Item No.: 24B-TTC-04

## NCUTCD PROPOSAL FOR CHANGES TO THE MANUAL ON UNIFORM TRAFFIC CONTROL DEVICES

**COMMITTEE / TASK FORCE:** Temporary Traffic Control Technical Committee  
**ITEM NUMBER:** 24B-TTC-04  
**TOPIC:** Pedestrian Channelizing Devices  
**ORIGIN OF REQUEST:** Tim Lang – TTC Committee  
**AFFECTED SECTIONS OF MUTCD:** Section 6K.02 Pedestrian Channelizing Devices  
Figure 6K-2

### Figure 6K.02. Pedestrian Channelizing Device

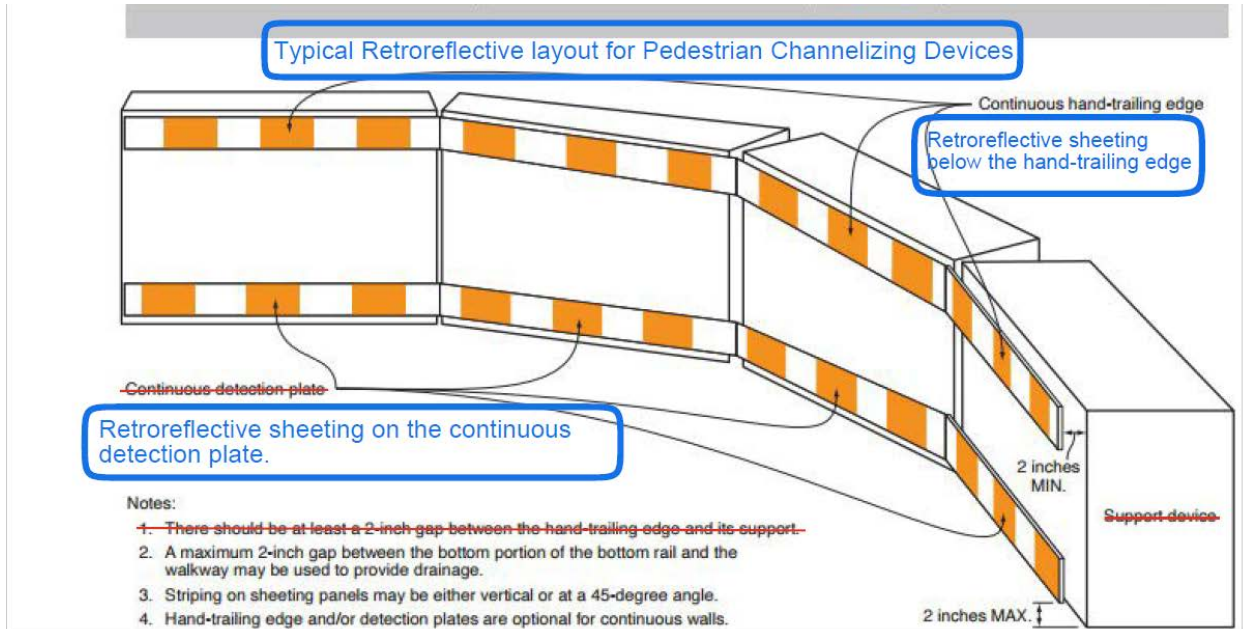
The verbiage in Section 6K.02 and Figure 6K-02 should be revised to incorporate all Pedestrian Channelizing Devices. These devices come in various shapes and sizes, and the Task Force has attempted to accommodate this diversity. The current version shows hand-trailing edges with a support device. However, not all products require a hand-trailing edge to be attached to a support device, as some have a hand-trailing edge on top. Therefore, the figure is proposed to be adjusted to include additional products. Two figures are included in the proposed change: one marking the current figure and one “clean” figure.

[This is showing the proposed changes to the current drawing]

Retroreflective areas can be distributed in a manner that ensures visibility and detection without necessitating a single continuous application.

**Figure 6K-2. Pedestrian Channelizing Device**

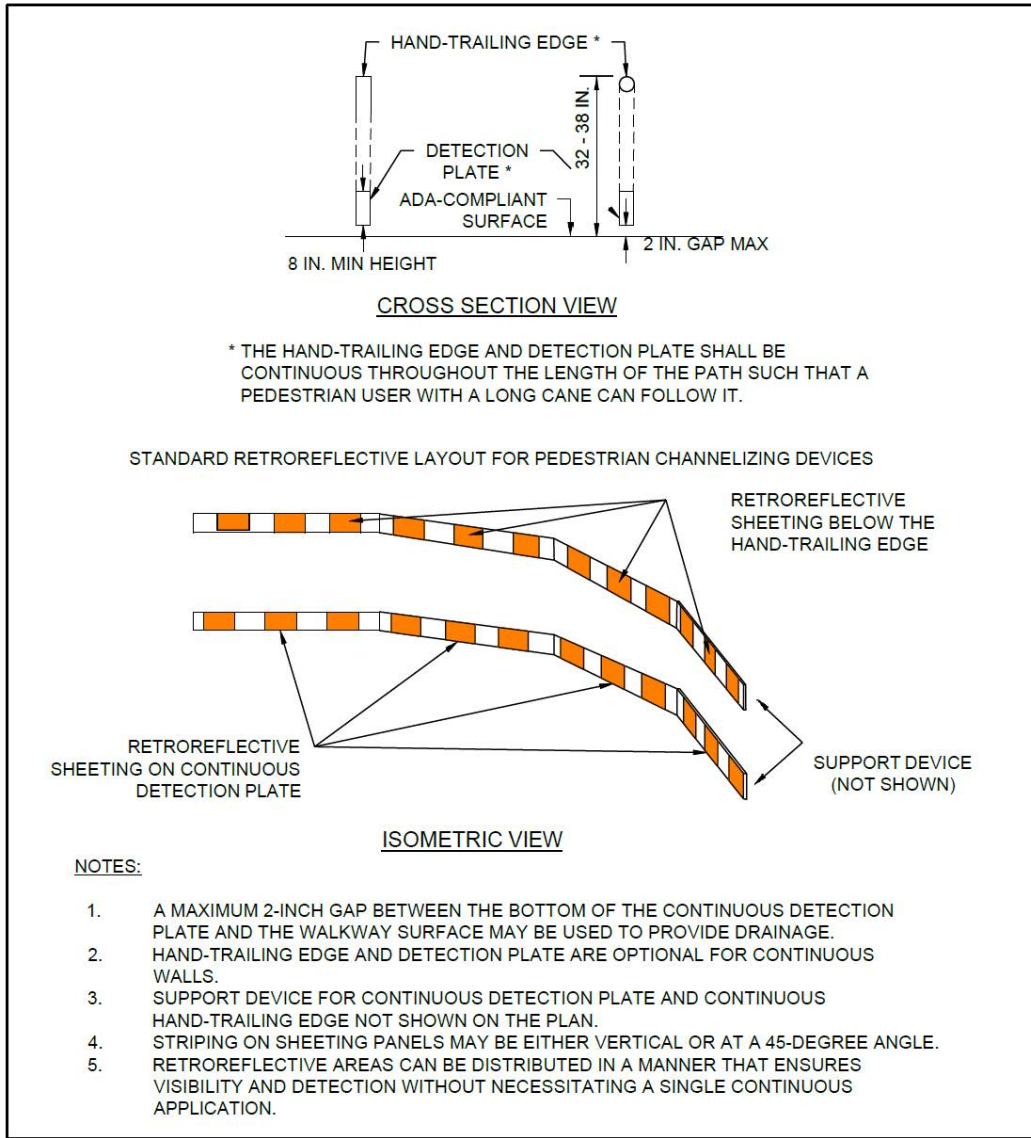
[New Drawing recommended for Figure 6K-2. This drawing was created to highlight the current design of pedestrian channelizing devices.]
